Access Compliance Report

Public Rights-of-Way

(Curb Ramps)

Intersection ID: 43757	Main Street: DERVISH_LN	Cross Street: ZIEGLER_LN	Location:	N
ADA ID: ABB564EDCC8D	Ramp Type: PerpDiag	Initial Pass/Fail: Fail	Overall Compliance: No	Severity Score: 33.75
Codes/Mitigation Info/Possible Solution		Field Measurements/Component Compliance

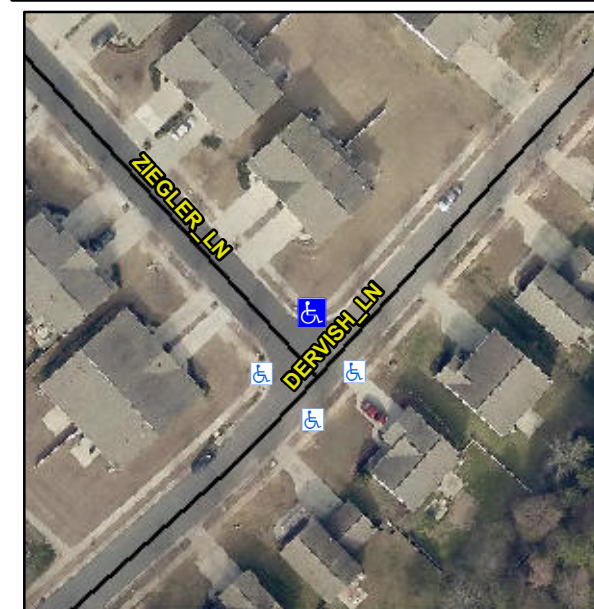
Not Found, R304.5.1, R304.2.2, R304.5.3

Compliance	Description	Data	Compliance	Description	Data
N/A	Ramp Length (in)	46.5	No	Ramp Slope (%)	10.5
No	Ramp Width (in)	46.0	No	Ramp XSlope (%)	5.7
N/A	Flare Type LT	N/A	N/A	Flare Type RT	N/A
N/A	Flare Slope LT (%)	N/A	N/A	Flare Slope RT (%)	N/A
N/A	Flare Traversable LT?	N/A	N/A	Flare Traversable RT?	N/A
N/A	Landing Length (in)	N/A	N/A	DWS Provided?	N/A
N/A	Landing Width (in)	N/A	N/A	DWS Contrast?	N/A
N/A	Landing Slope (%)	N/A	N/A	DWS Length (in)	N/A
N/A	Landing X Slope (%)	N/A	N/A	DWS Full Width?	N/A
N/A	Landing Curb? (Y/N)	N/A	N/A	DWS Offset (in)	N/A
N/A	Shared Landing?	N/A			
N/A	Gutter Ponding?	N/A	N/A	Gutter Slope (%)	N/A
N/A	Gutter Lip Ht (in)	1.0	N/A	Gutter X Slope (%)	N/A
N/A	Painted X Walk1?	No	N/A	Painted X Walk2?	No
	X Walk 1 Direction	To SW		X Walk 2 Direction	To SE
N/A	X Walk 1 Width (in)	N/A	N/A	X Walk 2 Width (in)	N/A
	X Walk 1 Slope (%)	0.2		X Walk 2 Slope (%)	6.2
	X Walk 1 X Slope (%)	3.8		X Walk 2 X Slope (%)	5.0

Remove & Replace Curb Ramp With Two New Directional Ramps or Equivalent.
